# ROAD SAFETY INSPECTION

## Harris Road (No 2040431), Picton between Slk 0.00 - 1.20.

**Inspection Ref: bbc2020.163**

**City of Bunbury**

**Figure 2 - Shows estimated curve radius**

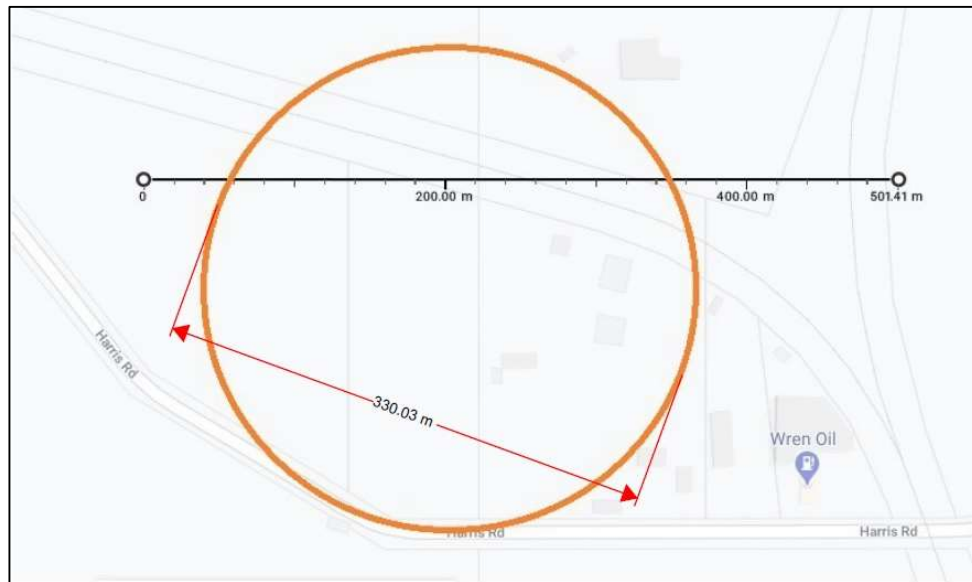
The curve at Slk 0.26 is estimated to have a radius of approximately 165 m using mid chord measurements and basic drawing techniques (Note: the actual radius should be determined by surveying the site), see Figure 2 below.

The site inspection determined that the superelevation of the curve was about 4%. Using figure 7.8 Rural Road from Austroads Guide to Road Design Part 3: Geometric Design (2016) and a radius of 165 m, the operating speed should be approximately 70 km/h. The curve radius and superelevation need to be confirmed.

There are no advance warning signs for the curve.

Advance curve warning signs should be placed where the operational speed is lower than the posted speed. Consideration to placing additional measures such as guideposts, edge lines with audible tactile marking, raised reflective markers on the centreline, pavement widening or chevron alignment markers.

Determine the radius, superelevation and recommended operating speed of the curve. Install advance curve warning signage and consider additional measures (Speed advise tag, guideposts, raised pavement markers, edge line with audible tactile marking, pavement widening) to guide the road user.

Findings and Recommendations	Project Manager		
	Agree / Disagree	Reason for Disagreeing	Proposed Action and Comments
<p><b>3.2 Finding – Isolated Curves of Small Radius.</b></p> <p>An isolated curve causing a sudden speed reduction elevates the risk of an Off-Path casualty crash.</p>			
<p><b>Recommendation</b></p> <p>Determine the radius, superelevation and recommended operating speed of the curve. Install advance curve warning signage and consider additional measures (Speed advise tag, guideposts, raised pavement markers, edge line with audible tactile marking, pavement widening) to guide the road user.</p> <p><b>[IMPORTANT   VERY HIGH]</b></p>	Agree		Install advanced warning signs/advisory speed signs, guideposts and audible edge lines at isolated curves of small radius, pending radius investigations – to be included in Harris Road Stage 2 Design (Applying for RRG & Blackspot for Construction).

Figure 3 - Sketch from Austroads Road Design

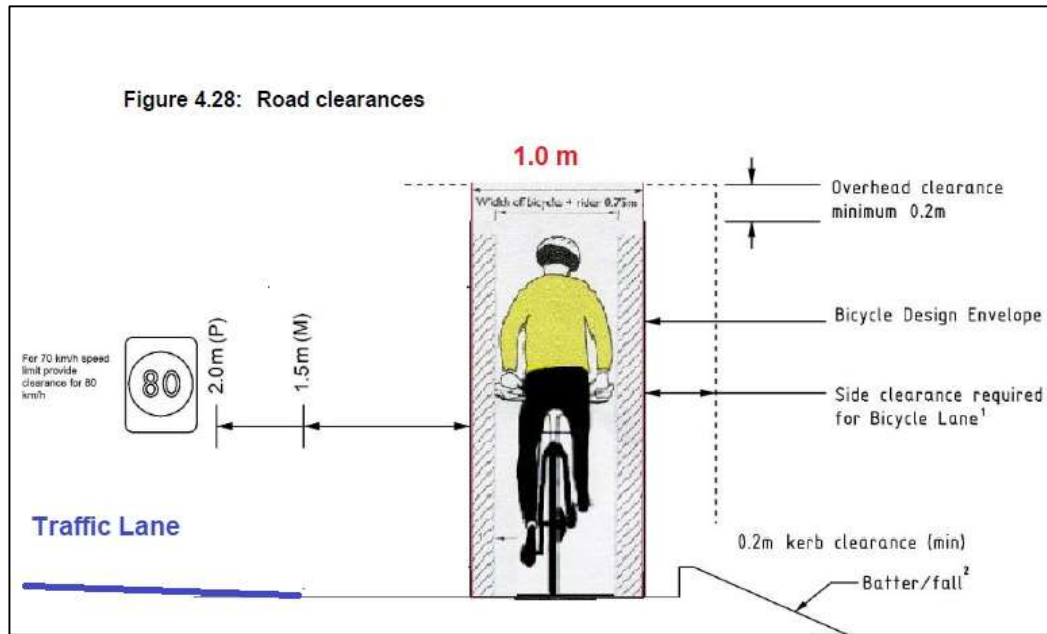
*Austroads Guide to Road Design Part 3: Geometric Design (2016)* indicates that due to the side wind forces exerted on cyclists from heavy vehicles, roads should be designed to provide satisfactory clearances between the bicycle envelope and passing vehicles. The clearance that should be provided between a cyclist envelope and a truck in the adjacent lane to enhance cyclist safety is 1.5 m for 70/80 km/h speed zones. The minimum cycle lane wide is 1.0 m.

Provide bicycle lanes to Harris Road as per the Austroads Guides.

**Finding 2.3 – Existing power poles with steel supports approximately 4.0 m from the traffic lane within the clear zone.**

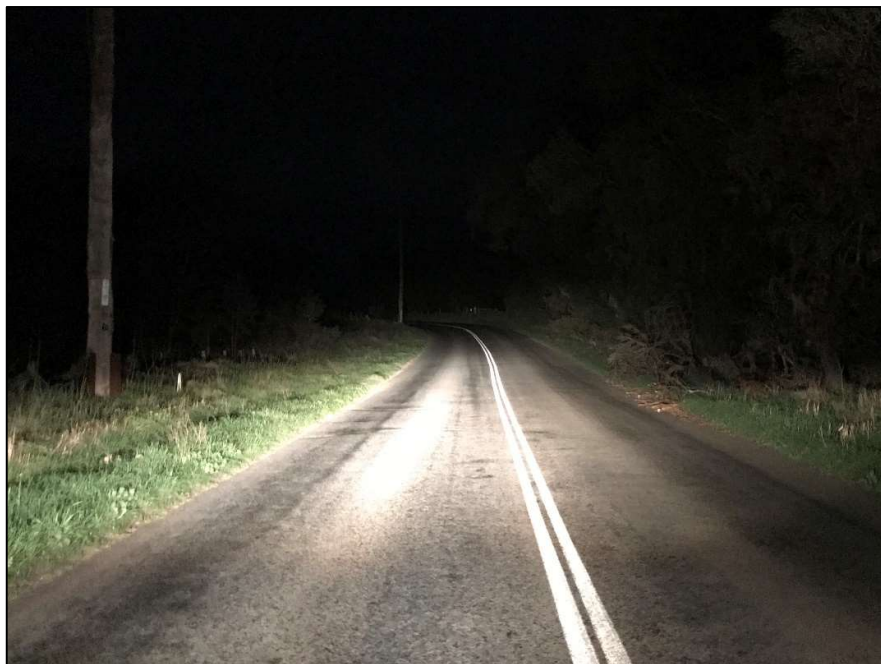
There are large power poles in the northern verge and numerous mature trees along the southern road verge that pose a risk to vehicle occupants in the event an errant vehicle leaves the roadway.

The power poles in the northern verge are a significant size, reinforced with steel and located approximately 4 m from the edge of the traffic lane. Widening of the existing road pavement would result in the poles being closer to the traffic lane.

The power poles are significant assets and would be a high cost to move or underground, placing barriers and or a combination of moving the traffic lane away from the power poles may achieve suitable mitigation.

Provide suitable clear zones along the road, when this is not possible, consider other mitigations such as a road safety barrier, edge lines, lower speed etc.

Findings and Recommendations	Project Manager		
	Agree / Disagree	Reason for Disagreeing	Proposed Action and Comments
<p><b>3.3 Finding – Non-Frangible Objects in the Clear Zone.</b></p> <p>There are large power poles in the northern verge and numerous mature trees along the southern road verge that pose a risk to vehicle occupants in the event an errant vehicle leaves the roadway.</p>			
<p><b>Recommendation</b></p> <p>Provide suitable clear zones along the road, when this is not possible, consider other mitigations such as a road safety barrier, edge lines, lower speed etc.</p> <p><b>[IMPORTANT   HIGH]</b></p>	Agree		Clear trees within the clear zone, install audible edge lines, install barriers and lobby Main Roads for Speed Reduction – to be included in Harris Road Stage 2 Design (Applying for RRG & Blackspot for Construction).
